Item Name: Replacement Skidtube (Fits LH or RH)

DRAWING NO. D2650	TITLE 206/407 SKIDTUBE ASSEMBLIES	REV. F	DART AEROSPACE LTD ENGINEERING ORDER		D.E.O. NO. D2650-F-1	SHEET NO. SHEET 1 OF 1	SCALE NTS
DRAWN <i>JP</i>	CHECKED <i>A.P.</i>	MFG. APPR. <i>AA</i>	APPROVED <i>[Signature]</i>		DE APPR. <i>[Signature]</i>		
DATE 12.10.12	DATE 12.10.22	DATE 12.10.22	DATE 12.10.22		DATE 12.10.22

CHANGE C'BORED WELDED CROSSBOLT SPACERS TO SWAGED SPACERS

DETAIL B

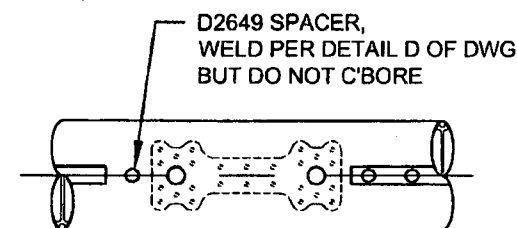
C'BORED HOLES ARE **NOW SWAGED** PER DETAIL G BELOW. FOR THE Ø0.375 HOLE THAT IS NOT C'BORED, WELD PER DETAIL D OF DWG (SEE AMENDED DETAIL B FOR REFERENCE).

AMENDMENT TO DETAIL B
NOT TO SCALE

DETAIL G

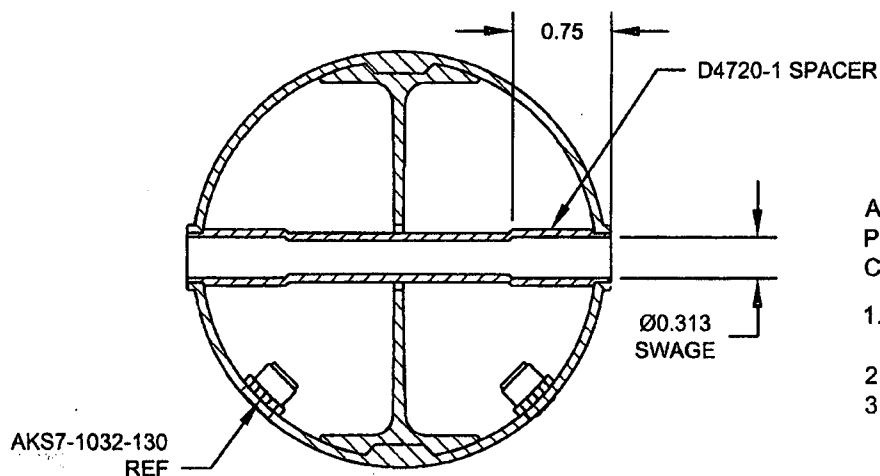
FOR Ø0.375 HOLES ONLY
FOR HOLES THAT ARE CURRENTLY C'BORED ONLY
NOT TO SCALE

AFTER DRILLING AND BENDING ASSEMBLY
PERFORM THE FOLLOWING FOR Ø0.375 HOLES THAT ARE
CURRENTLY C'BORED:

1. INSERT D4720-1 SPACER, 16 PL (-1) OR 17 PL (-3)
OR 19 PL (-5) OR 23 PL (-7)
2. SWAGE TO Ø0.313 X 0.75 DP PER QSI 002
3. TRIM / GRIND FLUSH PER QSI 002
